M3 Junction 9 Improvement

Scheme Number: TR010055

8.26 Applicant Response to Questions from the ExA on the Report on the Implications for European Sites

Version	Date	Status of Version
Rev 0	27 October 2023	Deadline 6

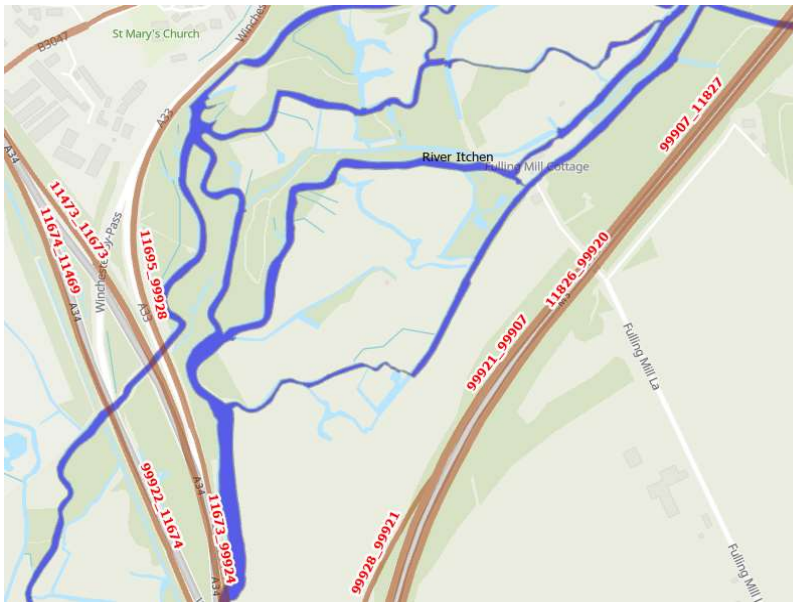
<p>undertaken to assess whether the projects in combination generated >1%. The extent of in-combination traffic included in the assessment is also unclear as the assessment used “DS-DM” which includes in combination traffic in the transport model, but not in the calculation of exceedances.</p>	
<p>P34 –potential operational impacts from air quality are noted – further information provided in Appendix F table F2 – and LSE cannot be excluded. NE agrees with this conclusion.</p>	<p>Noted</p>
<p>However, construction impacts are not included as having LSE and it is not clear why given they are listed as a potential pathway to AQ impacts at p18 and the potential is listed at the assessment criteria at p24 onwards (e.g. works to the existing carriageway, walking/cycling/ horseriding facilities, areas for drainage requirements, utilities diversion, construction phase vehicle movements could result in changes to air quality as a result of construction activities) – without further assessment in the section at p32 onwards. At our meeting on 8 June 23 it was accepted (subject to seeing the assessment within the HRA) that potential air quality impacts cause by construction vehicle movements and generator emissions had been considered and that no significant effects were identified due to the location and expected duration of vehicle movements. However, this does not appear to be addressed in the HRA. In practice the mitigation measures to reduce dust listed in Section 4.2.14 would</p>	<p>Further information has been added to the Habitats Regulations Assessment (7.5, Rev 2), to address this point.</p>
